CCK-2874.00-3-25 New Environmental Quality Management Center BP02 ADDENDUM #1 05/01/2025

## ADDENDUM #1

project UK Environmental Quality Management Center

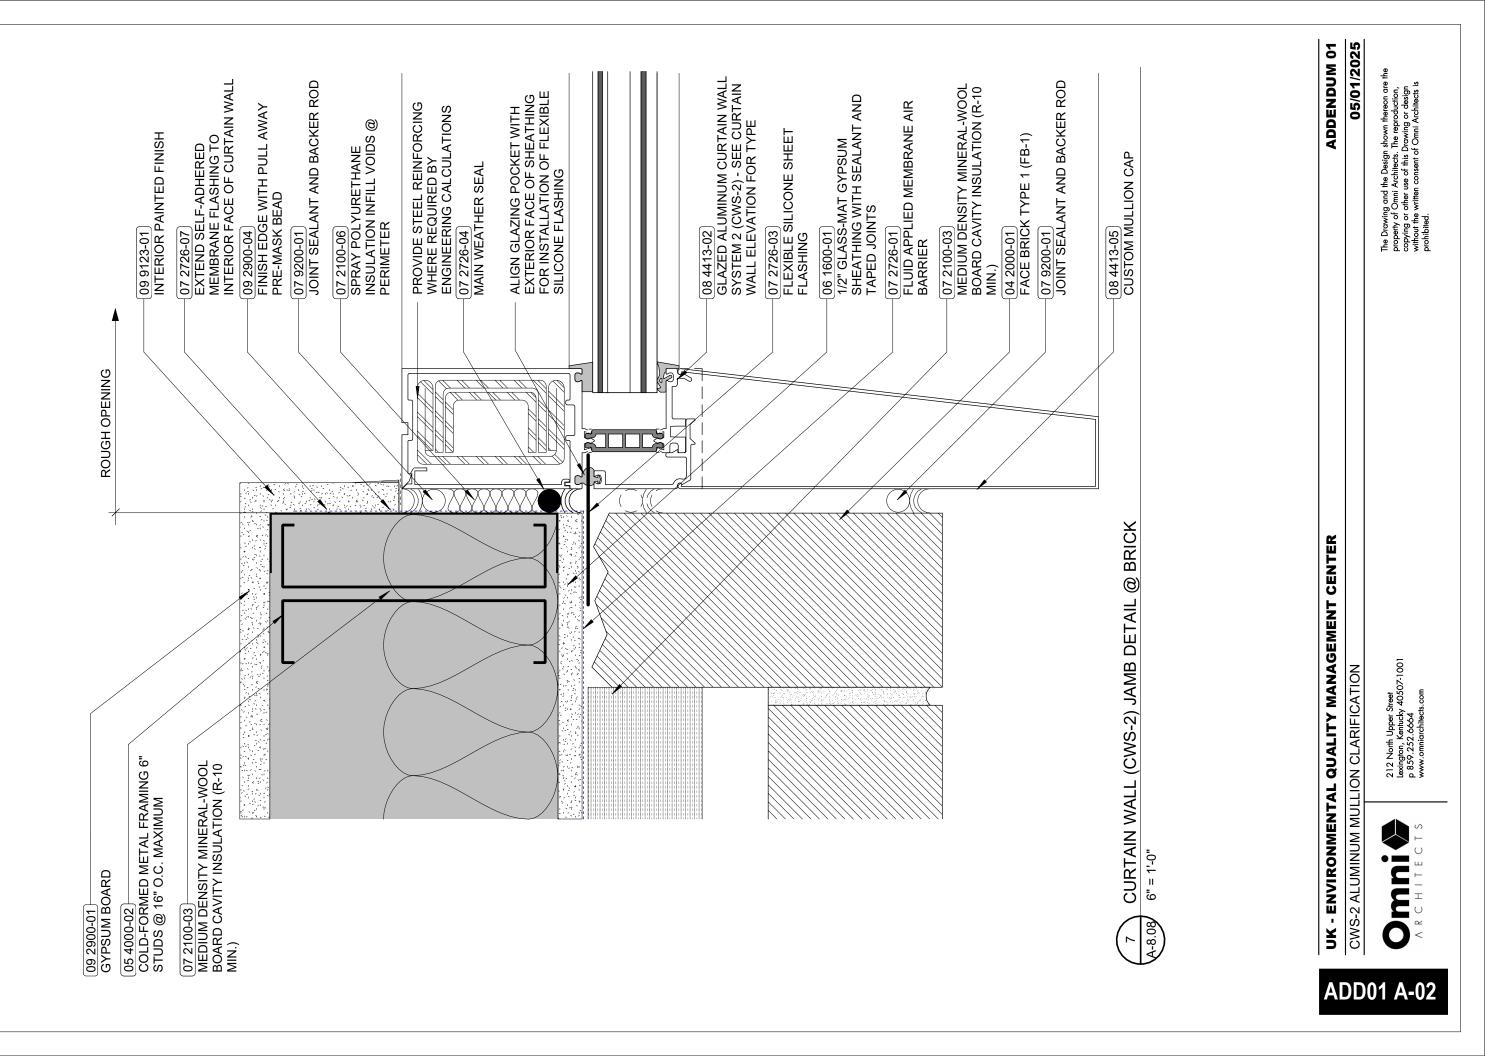
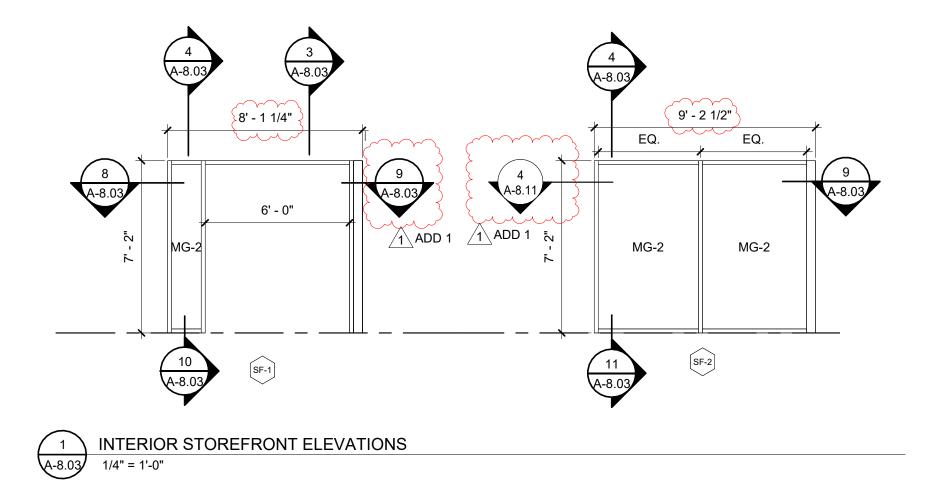
- 2. Sheet A-7.03 Roof Details: This sheet includes several roof details, specifically details 1 through 3 identify roof details along the east side of the second floor of the B Occupancy office building, and the transitions to the lower horizontal rated roof assembly of the H-2 occupancy. Sheet ADD01 A-01 has been provided to clarify with a 3D view where these three details take place. This new drawing will be located and listed as view 4 on sheet A-7.03 in the conformed drawings.

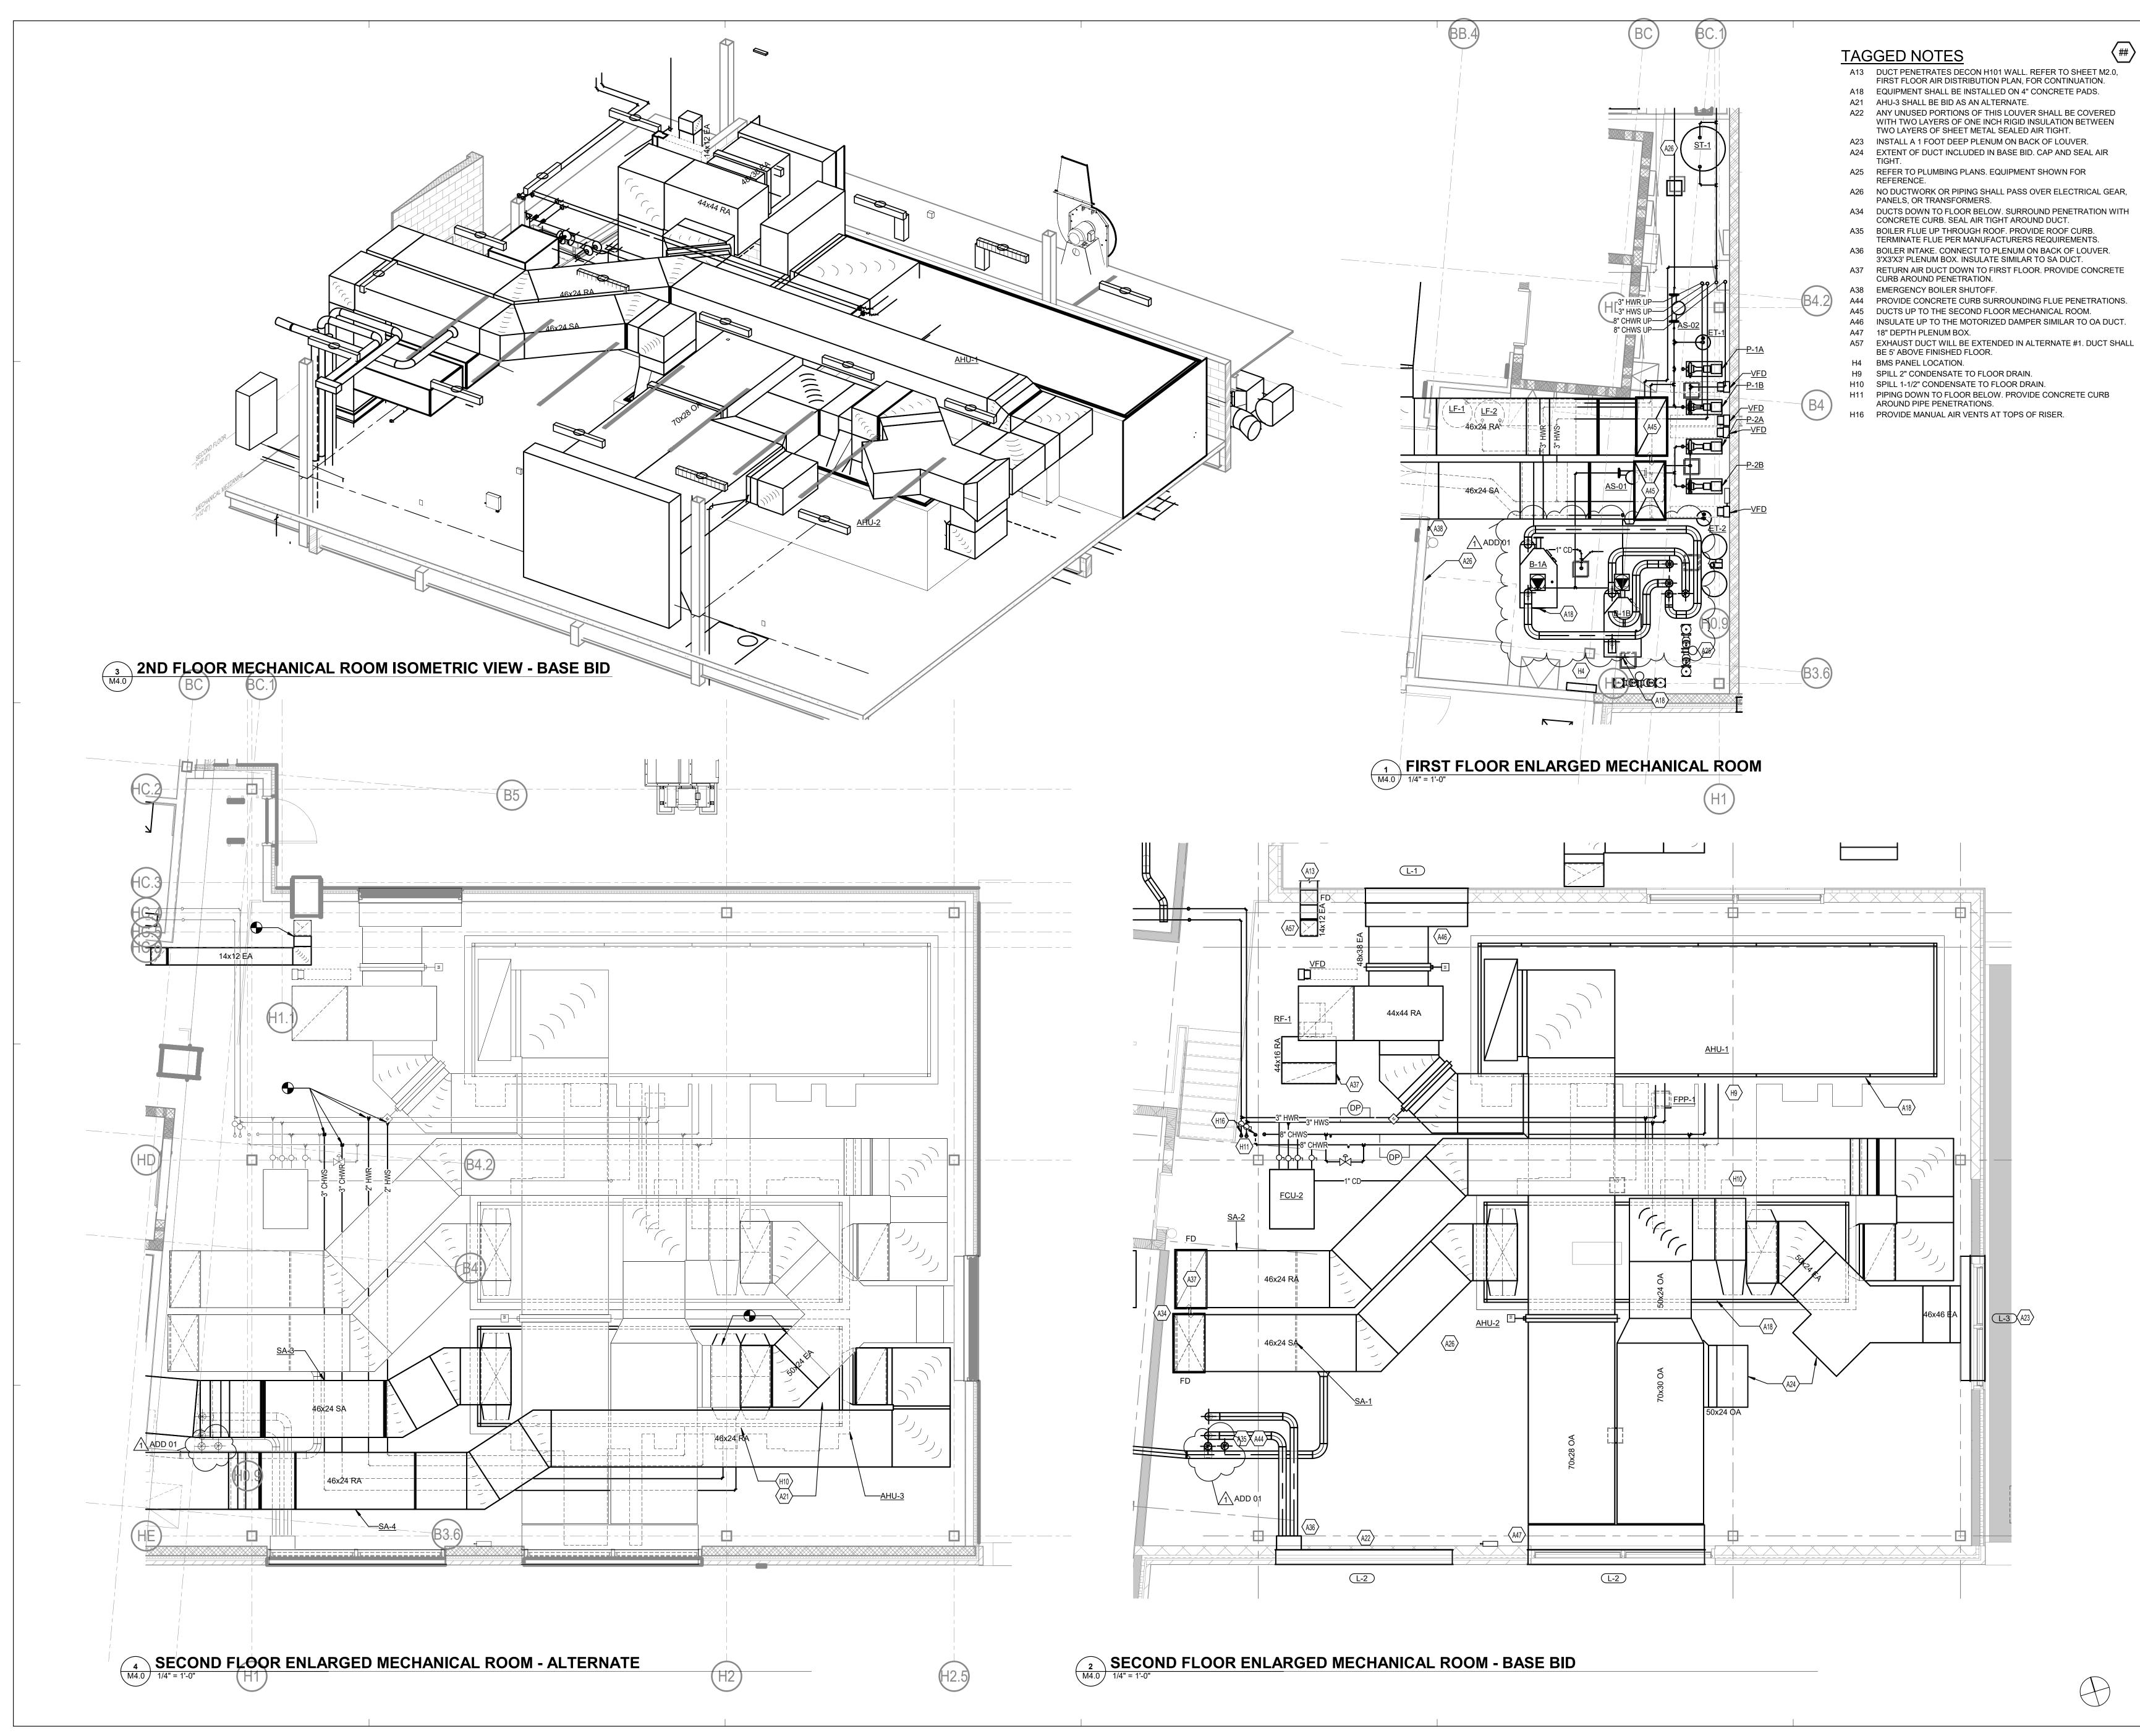
- 4. Drawing 1 on A-8.03 Interior Storefront Elevations SF-1 and SF-2: Reference the attached ADD01 A-03 for revised SF-1 and SF-2 elevations and revised detail references.
  - **a.** Sheet A-8.01 Door Schedule: The Door Schedule shall be revised to identify door A100A.2, which is located in SF-1, as an Interior door.
- 5. **Reference Specification 08 4413 "Glazed Aluminum Curtain Walls", article 2.11 A.2: Revise article** to read as follows: "Color and Gloss: Provide from the manufacturer full color range."
- 6. Reference Attached ADDENDUM #1 MEP document for additional addendum items.

**M4.0**

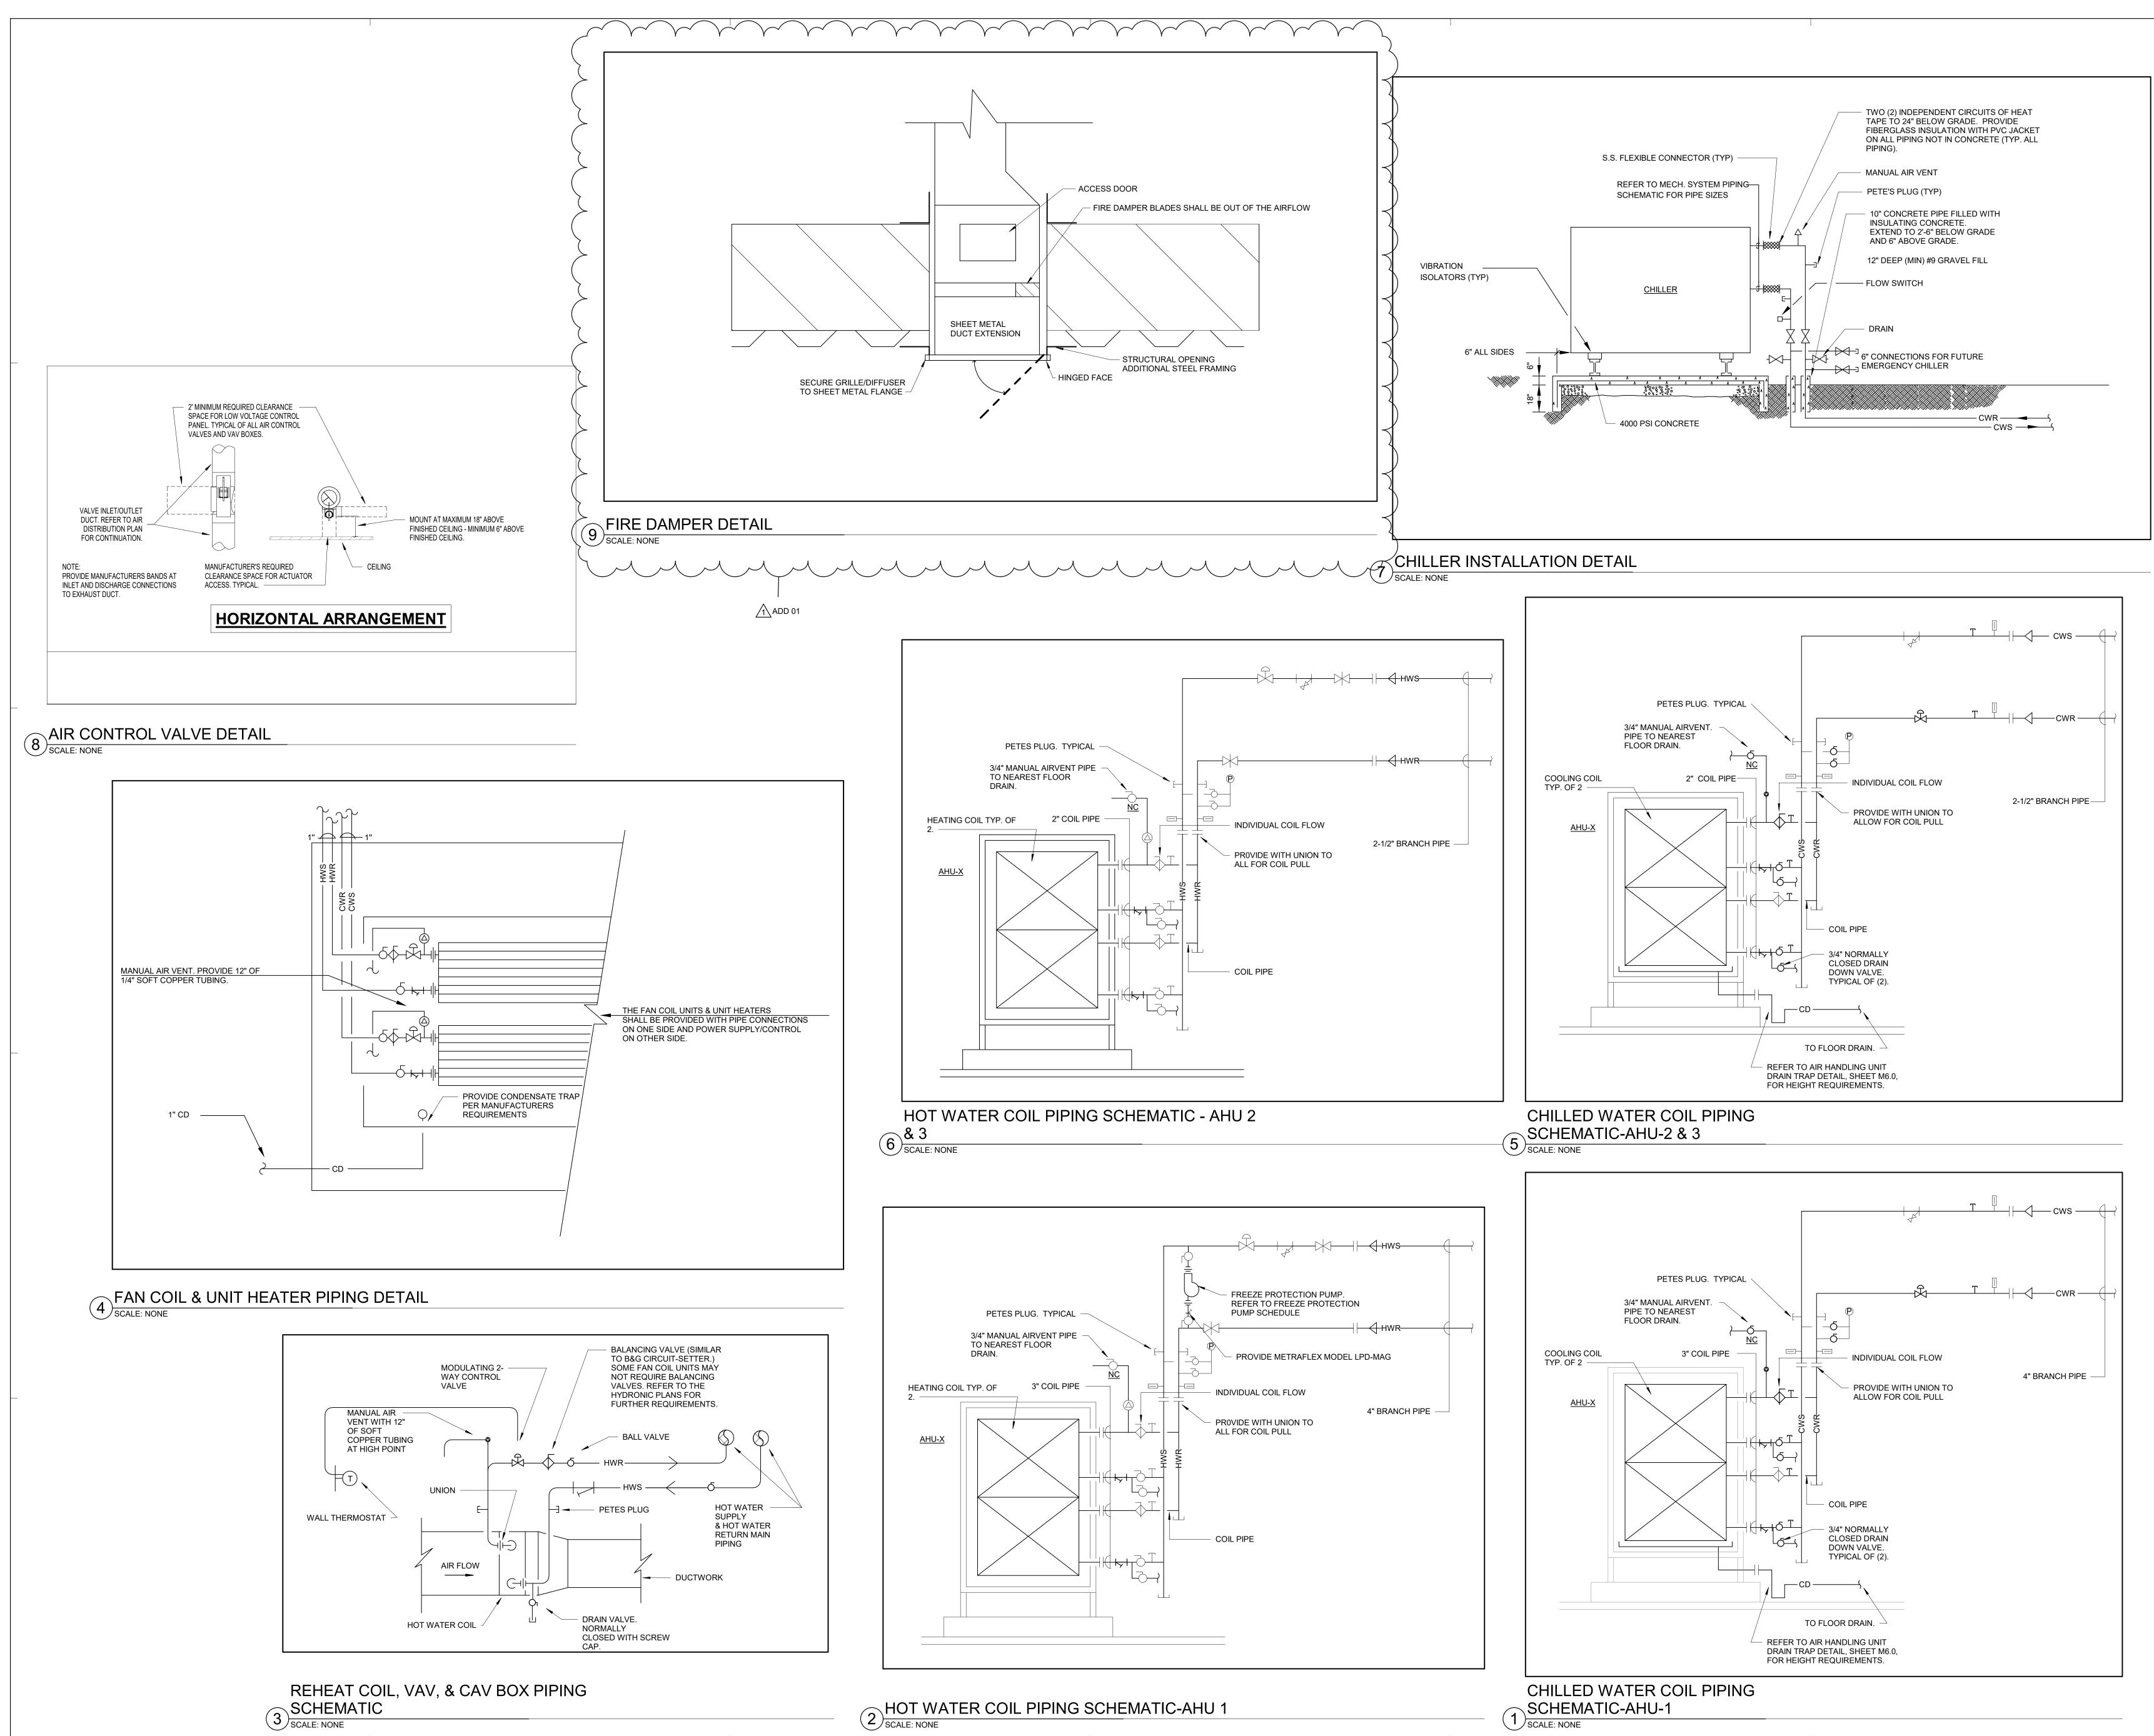
- Item #1 Refer to sheet M4.0 ENLARGED MECHANICAL ROOM A. Route flue between the AHU-3 supply and return ductwork. Shift the 46x24 return duct plan south approximately 1'-0".
